Re: Proposed hydro-electric generating station at the Bala falls

ADM Goyette suggested I contact you for the questions concerning her Decision Summary response e-mailed to me on January 2, 2018 for the Review request of ECA 0521-9XKKZ3 which I submitted through the Environmental Commissioner of Ontario for the proposed hydro-electric generating station at the Bala falls.

Composite drawing showing new evidence that could result in significant harm to the environment

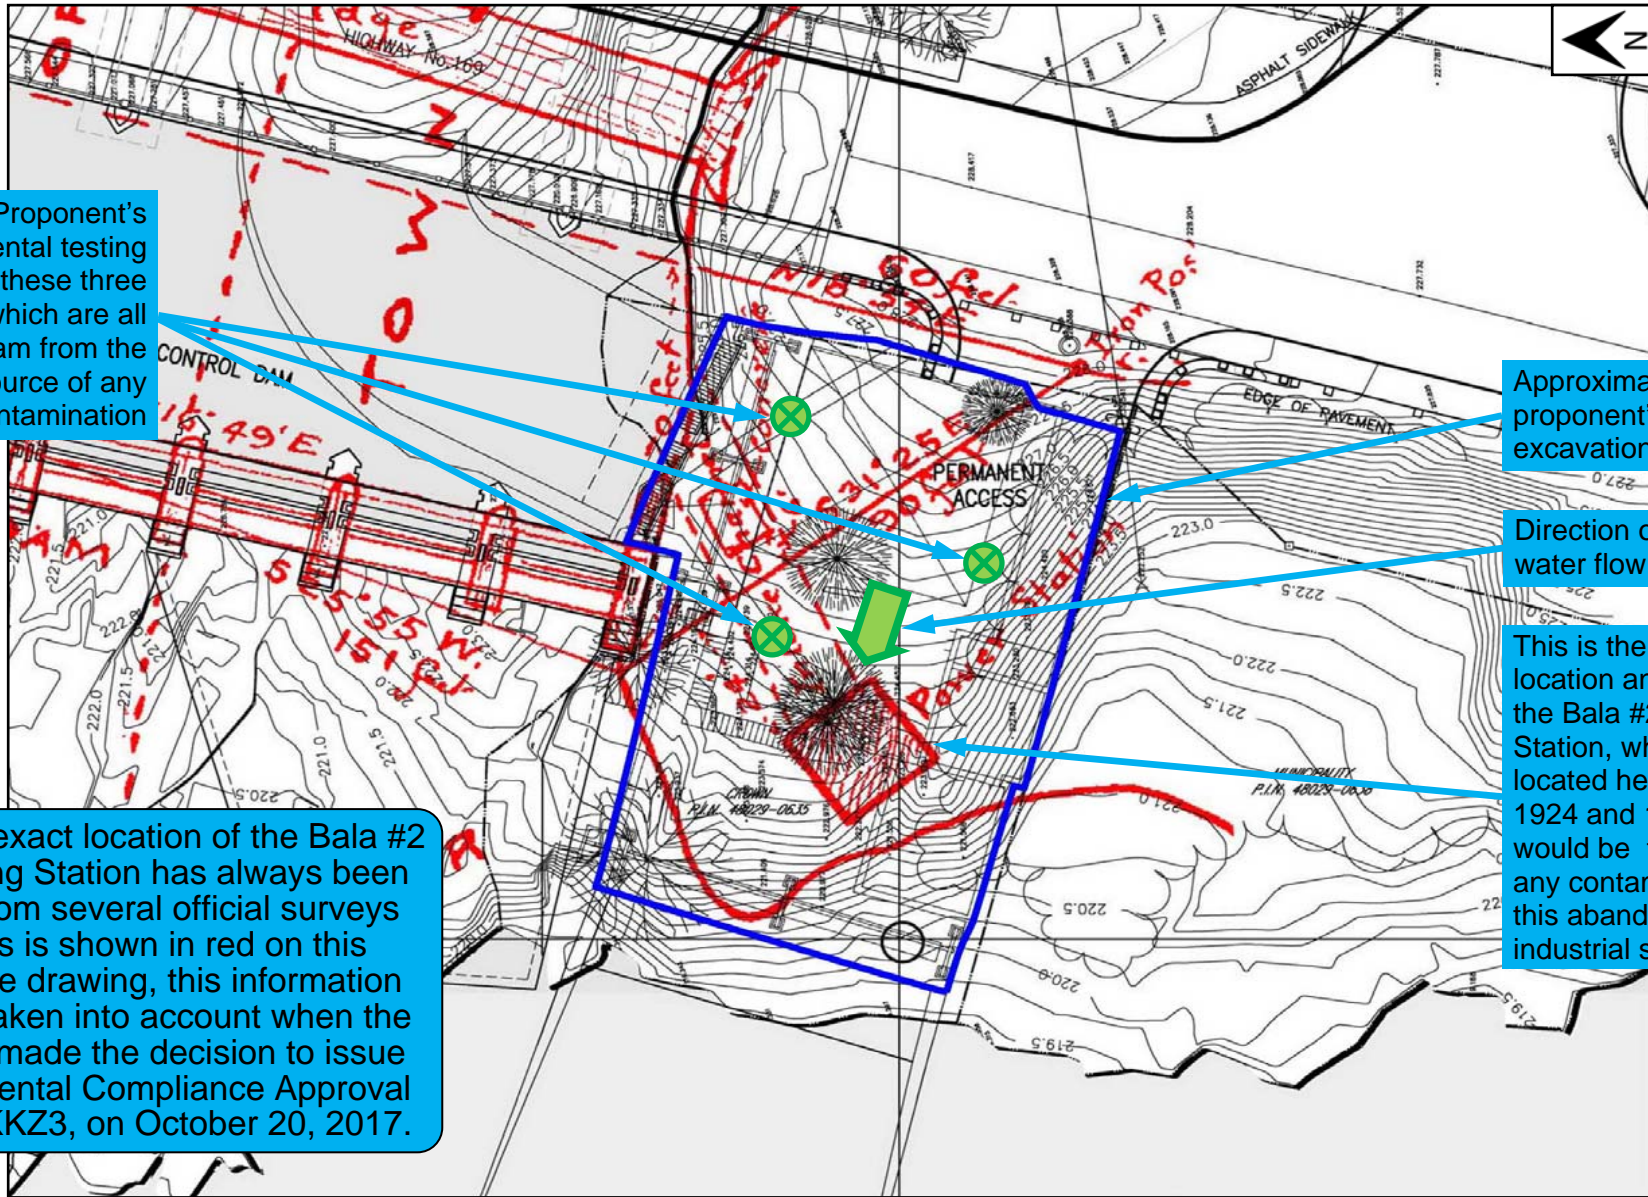
- As can be seen by the contour lines in the graphic in the Appendix to this letter, the "steep slopes" were the locations where the exploratory boreholes should have been drilled, as this would have been at or downstream of the source of contamination.
- As shown by graphic in the Appendix to this letter, all the exploratory boreholes were drilled upstream of the potential source of PCB contamination, so this testing would not show the PCB contamination, as this would all flow downstream and away from the exploratory boreholes.

The new evidence is that there exist official surveys showing the exact location and extent of the Bala #2 Generating Station, which would be the source of potential PCB contamination, which the ESA notes is a concern for this particular site. This new evidence is shown as the red lines on the Appendix to this letter, and this information was not sought for the ESA, so was not available to the MOECC when the decision to issue the ECA was made.

While the exact location of the Bala #2 Generating Station has always been known from several official surveys such as is shown in red on this composite drawing, this information was not taken into account when the MOECC made the decision to issue Environmental Compliance Approval 0521-9XKKZ3, on October 20, 2017.

Red lines above are a section of official Survey, entitled: "Plan of Part of the Town of Bala", by: "W. Galbraith, O. L. Surveyor, Bracebridge, Aug 30th 1924".

Black lines above are a section of drawing entitled: "Bala GS Key Plan", sheet: 131-13550-NBC-00 from WSP, dated November 28, 2013.
